Project Name: Land North of Folly View, Willersey

Project Number: P24-3059

Report Name: Flood Risk and Drainage Addendum

### **TOWN AND COUNTRY PLANNING ACT 1990 LEAD LOCAL FLOOD AUTHORITY RECOMMENDATION**

**RoFSW SECTIONS**  
**BROADWAY ROAD, WILLERSEY**

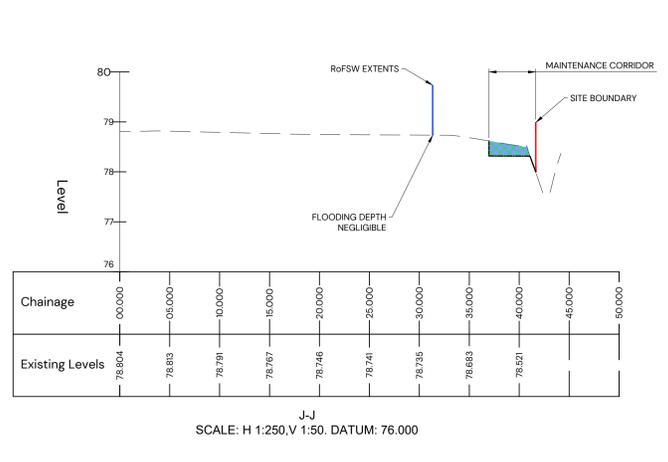
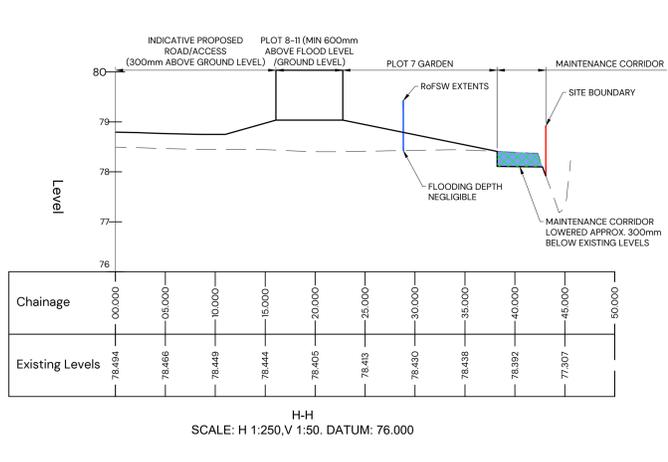
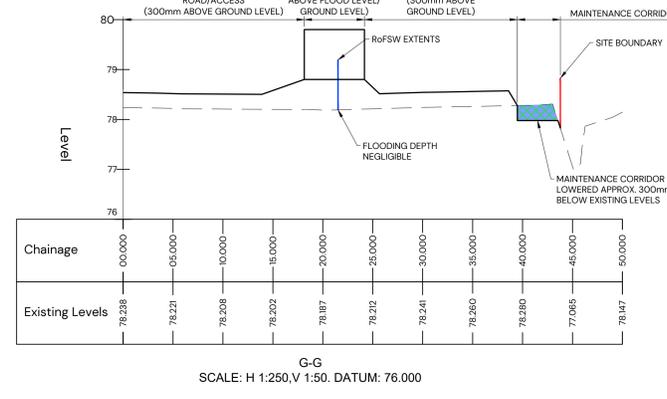
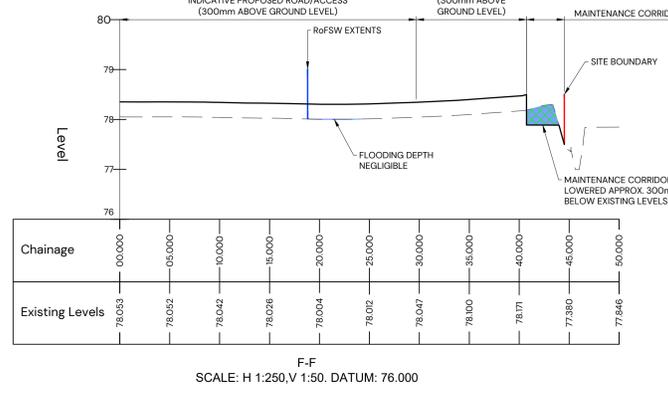
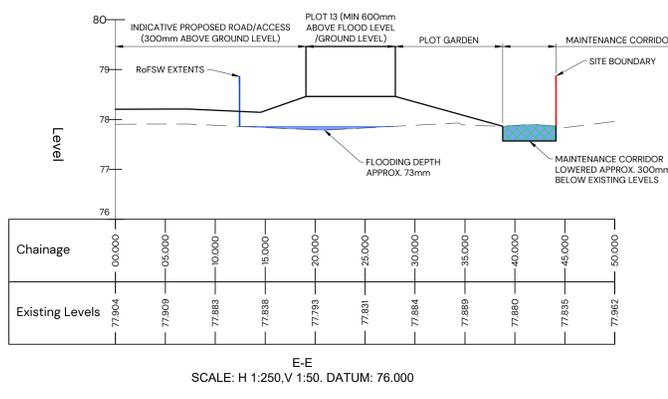
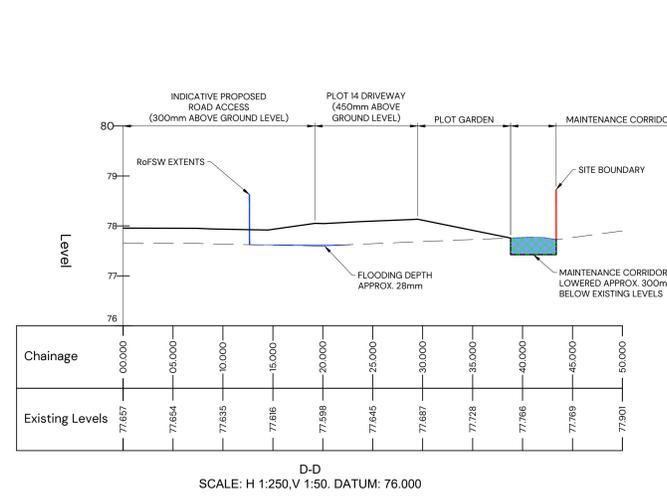
***“As shown in the Flood Risk Assessment and Drainage Strategy (P24-3059); September 2025) (FRA) the site is in flood zone 1 and mostly at very low risk according to the Risk of Flooding from Surface Water (RoFSW) maps. However, there is an area at medium and high risk along the eastern boundary in which, according to the masterplan, there will be properties situated. This could either put these properties at risk or displace the flood water and increasing the risk elsewhere, if not mitigated. No modelling has been carried out as it is being proposed to do so before a reserved matters application if the application is approved.*”**

***It should be noted that modelling of the watercourse was carried out to support a previous application (20/04553/OUT) and shows that the site might be at higher risk than the RoFSW maps show and the impact over a wider area of the site. This should be addressed in the application.”***

- 2.2. The Environment Agency (EA) RoFSW mapping indicates the flood risk along the eastern site boundary is up to 0.2 metres (m) in the location of the proposed properties. The mapping shows the areas with depths up to 0.3m are contained within the banks of the watercourse.

- 2.3. A review of the site topographical survey against the RoFSW 1 in 1,000 year plus climate change extents indicated the flood depths across the east of the site range between approximately 86 millimetres (mm) and negligible amounts. The RoFSW cross sections are presented in **Appendix B**.

- 2.4. The cross sections show the low flood volumes can be accommodated by lowering levels and through the landscape design within the maintenance corridor along the eastern site boundary. Finished Floor Levels (FFLs) would also be raised approximately 0.3m above the ground level to mitigate any residual flood risk. This approach and level analysis was deemed acceptable by the LLFA during the meeting.

- 2.5. The hydraulic modelling to support a previous application approximately 0.3 kilometres (km) to the north of the site was undertaken in 2014. It is considered this modelling is now outdated, and the latest EA data is more accurate than the model for the previous application; the rainfall data and EA models have since been updated and use more recent LiDAR information.
